ADDENDUM NO. 1

PN15210009 & 15210012 Kalaeloa Building 1874 & Building 1898
Construction of Two Stand-by Emergency Generators, Kalaeloa, Oahu, State
of Hawai'i, Department of Defense,
Hawaii Army National Guard, Job No. CA-202004-C6

- A. KALAELOA (BUILDING 1874) CONSTRUCTION OF STAND-BY EMERGENCY GENERATOR INSTALLATIONS DRAWINGS (7 SHEETS, E001, E101, E102, E103, E104, E201, E202)
- B. KALAELOA (BUILDING 1898) CONSTRUCTION OF STAND-BY EMERGENCY GENERATOR INSTALLATIONS DRAWING(4 SHEETS, E101,E201,E203,E402,)

STATE JOB NO. KALAELOA (BLDG 1874) CA-202004-C8

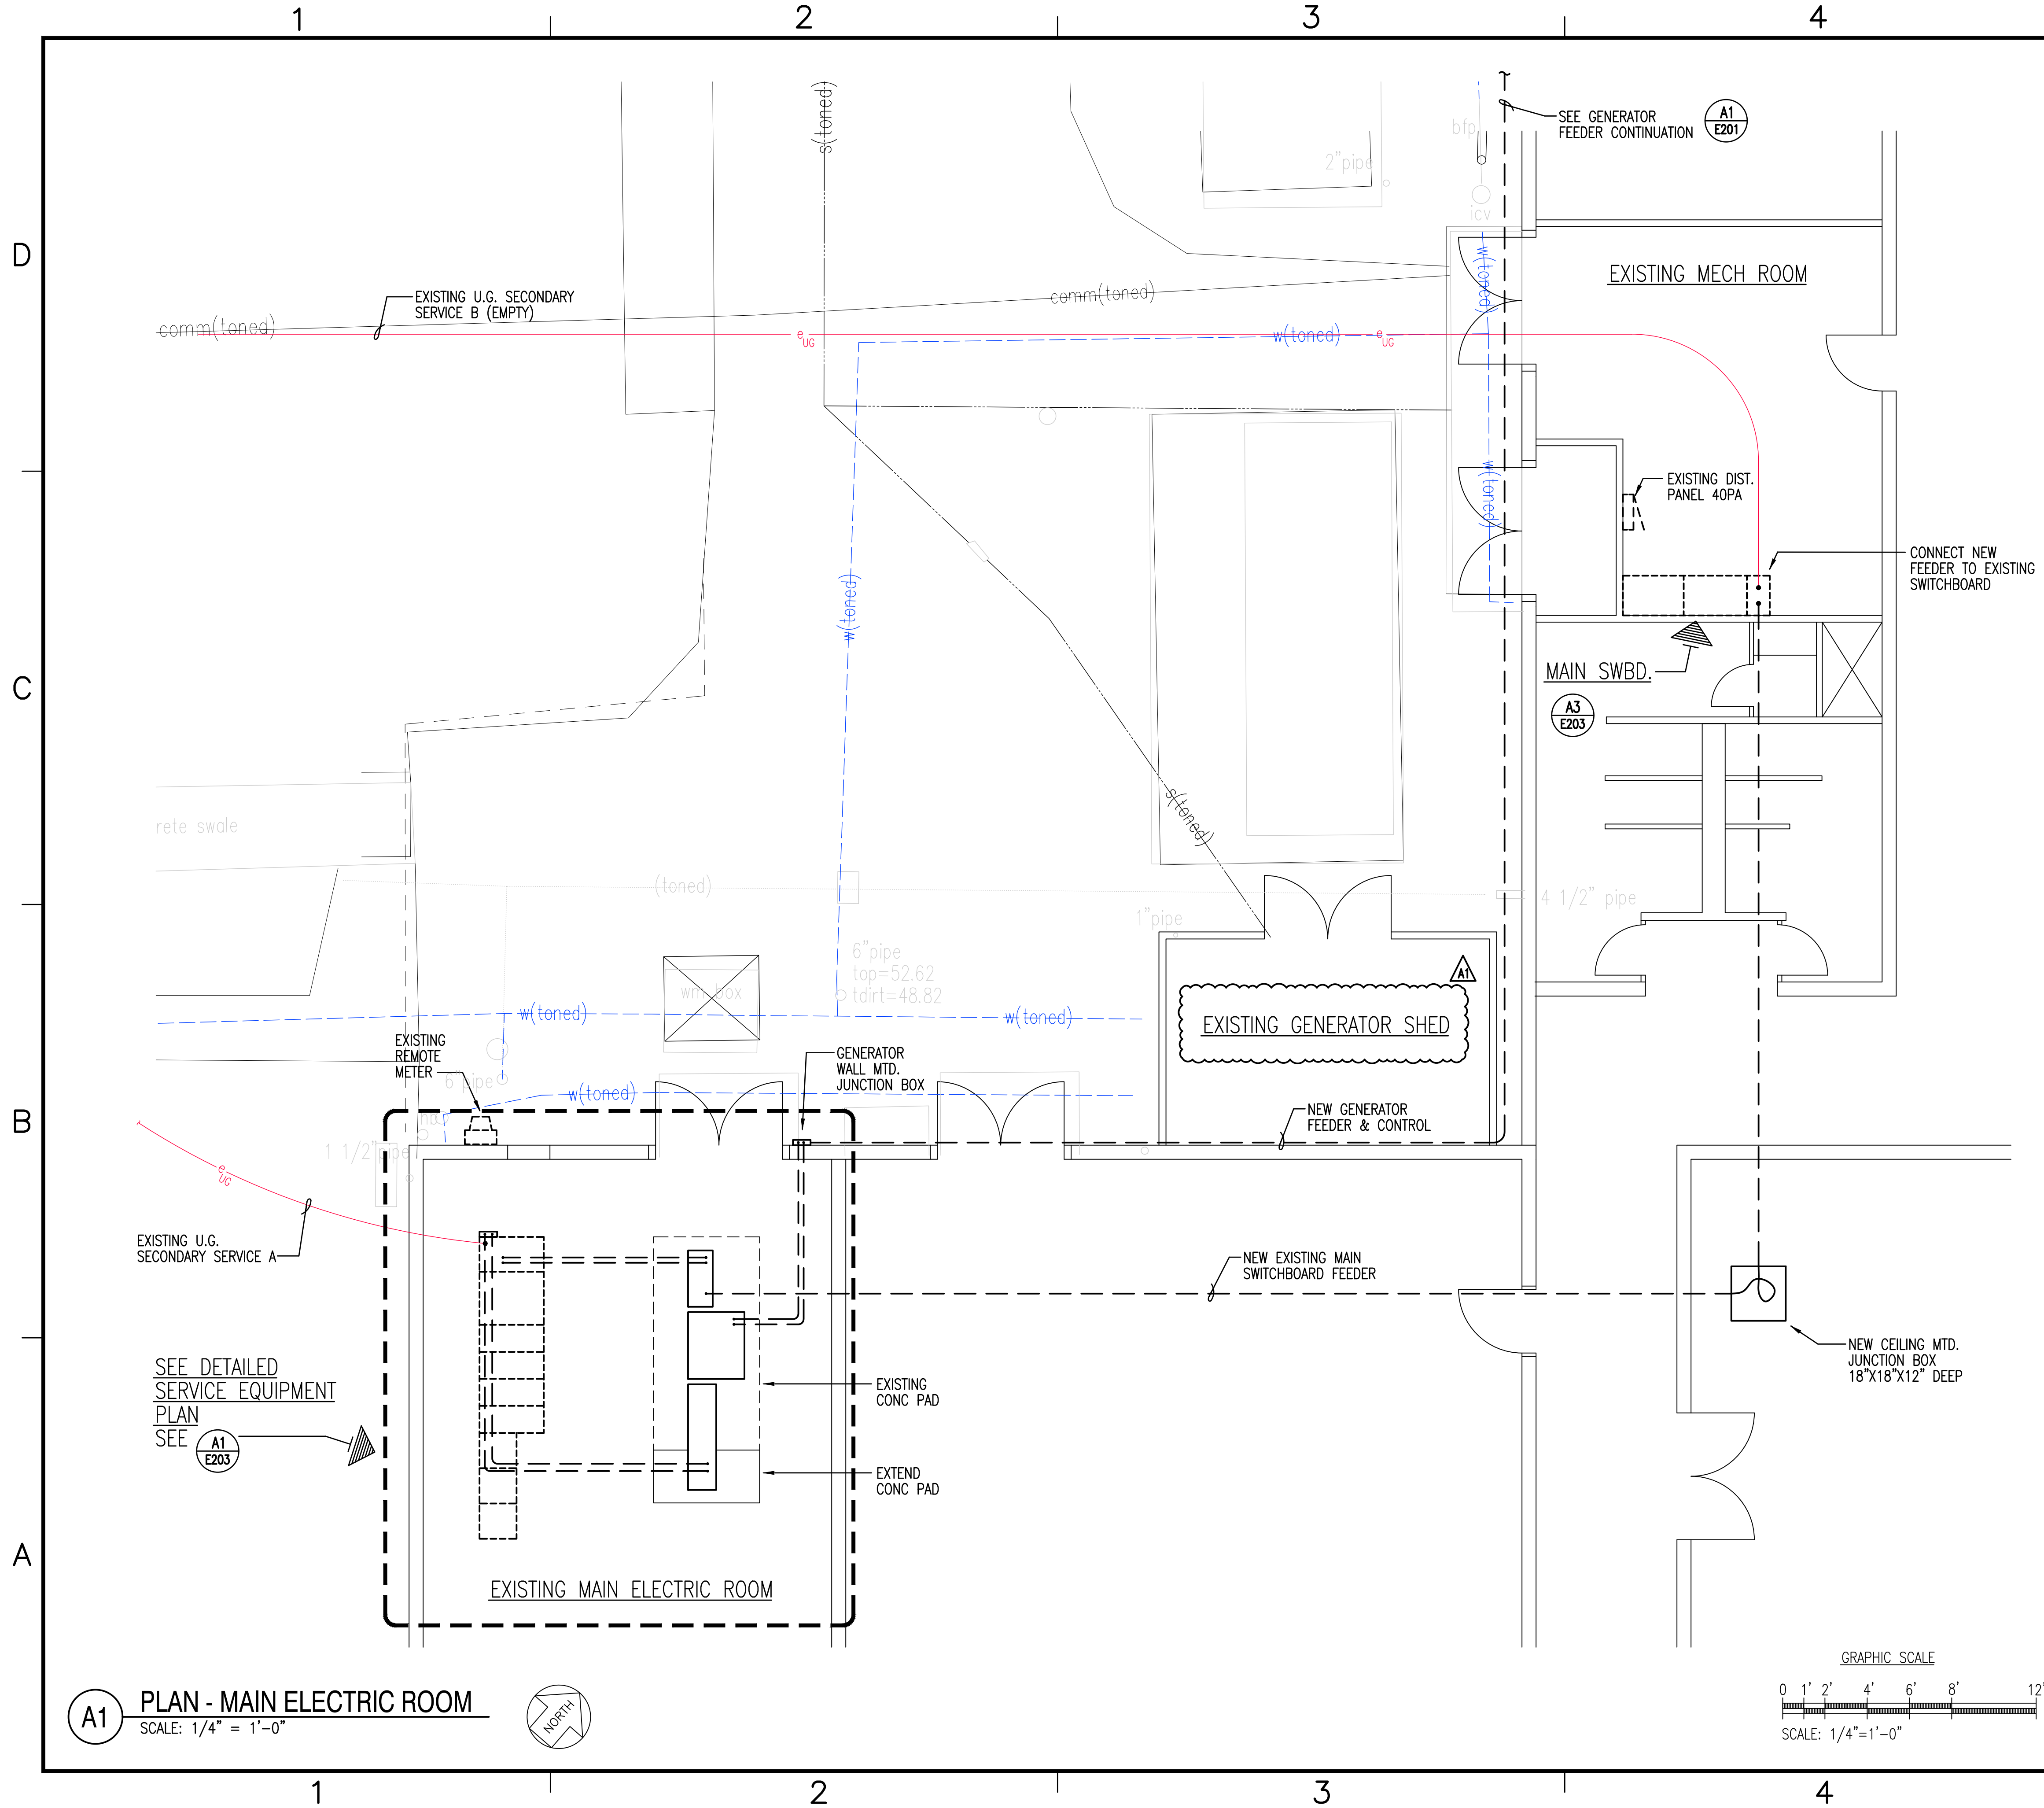
2. On sheet E-104 Note 3 calls for de-energizing the existing transformer. Is the intent to disconnect the medium voltage splice in the manhole or turn off the secondary at the transformer.

A. The de-energizing of the existing transformers will be performed by the respective utility companies. The Contractor will arrange for the work with the utility companies.
